# *City of Brisbane*

## *Planning Commission Agenda Report*

**SUBJECT:** **Parking Use Permit UP-1-20 and Grading Review EX-1-20; 130 Sierra Point Road;** R-1 Residential District; Use Permit to allow for nonconforming interior dimensions of a two-car garage and Grading Review for approximately 150 cubic yards of soil cut and export to accommodate a new single family dwelling on a 5,000 square-foot lot with a 33% slope; Wilson Yu, applicant and owner.

### **SUPPLEMENTAL REPORT**

**A102**

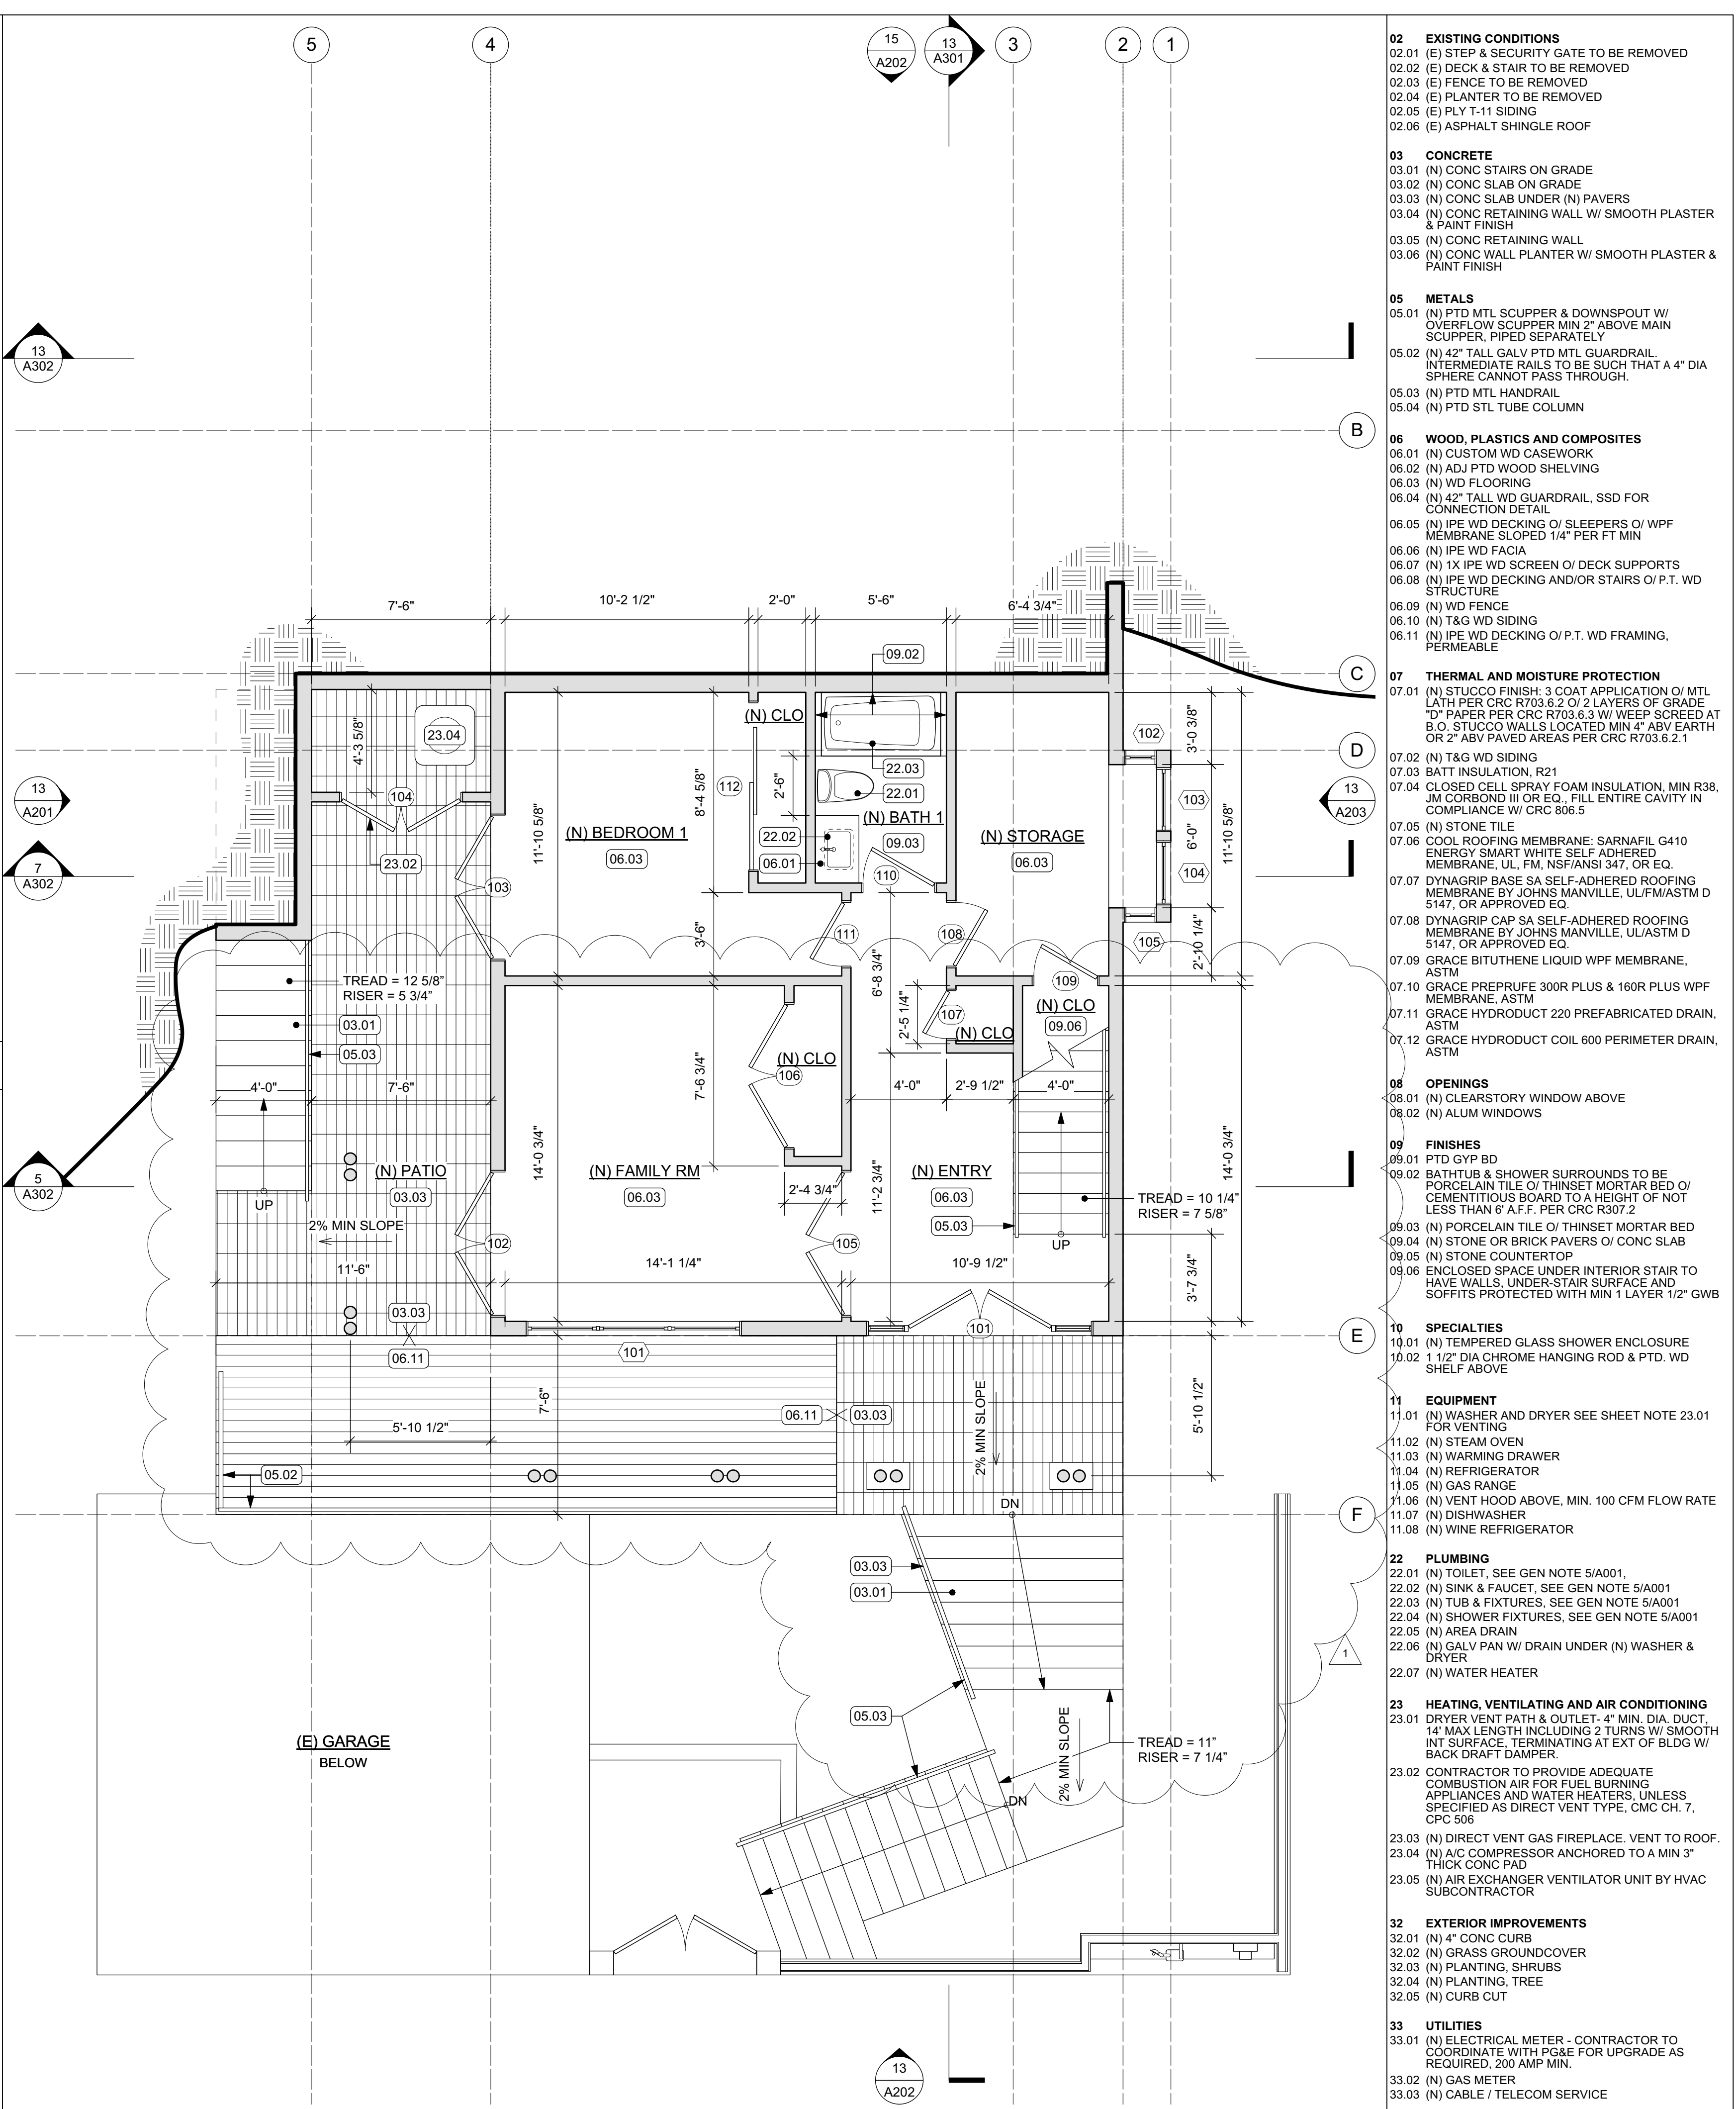
The requested Use Permit is to allow modification to the minimum interior dimension of garages (20' x 20' for a two-car garage) to accept the garage's existing interior dimensions. At 18' - 11" by 18' - 11", the garage's interior dimensions currently exceed the off-street parking facility design standards set forth in Table 1 of BMC Section 17.34.040 which would require an 18' x 18' area for two standard-sized vehicles. It should be noted that prior to the recent parking ordinance update in 2016, the standard interior dimensions for a two-car garage was 18' x 18'.

As noted above, the applicant intends to accommodate the required two covered off-street parking spaces within the existing 415 square foot garage with interior dimensions measuring 18' 11" by 18' 11" (see Sheet A102 of the applicant's plans, Attachment E.i). The minimum interior dimensions for two-car garages is 20' by 20'. The applicant requests a Use Permit to allow the nonconforming garage to meet the requirement for two covered off-street parking spaces per BMC §17.34.020.
